NUMBER: 23-021-23

Forward Facing Camera - Active Lane Management Inoperable

This bulletin involves replacing the sensor cover and re-calibrating the forward facing camera.

2022 (WL) Jeep Grand Cherokee

Fig. 1
Mirror Sensor Cover

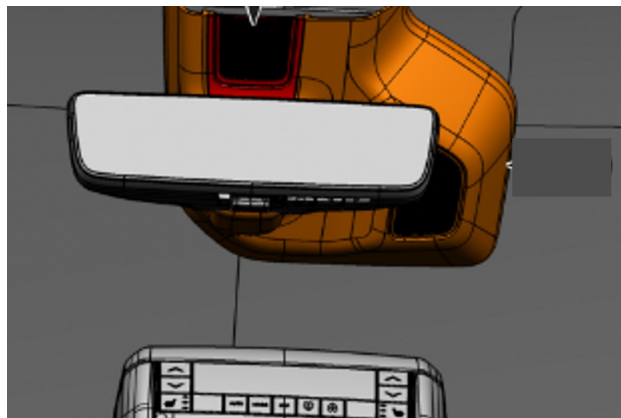
1. Is the vehicle on the RSU VIN list?
 - YES>>> Proceed to [Step 2](#).
 - NO>>> This Bulletin does not apply. Normal diagnosis should be performed.
2. Replace the sensor cover on the mirror ([Fig. 1](#)) . **(Service library can also be used for reference for the sensor cover only, the camera does not need to be removed)**. Refer to the detailed service procedures available in DealerCONNECT> Service Library under: Service Info>08 - Electrical / 8B - Driver Assistance / Assistance System Components / Cameras / Removal and Installation >Long Range Camera - Front.
 - a. Using a trim stick or suitable tool, remove the inside rearview mirror sensor cover and discard .
 - b. Reinstall the new rearview mirror sensor cover and snap into position ([Fig. 1](#)) .

NOTE: Long range camera front programming and calibration must be performed after the mirror sensor cover is replaced.
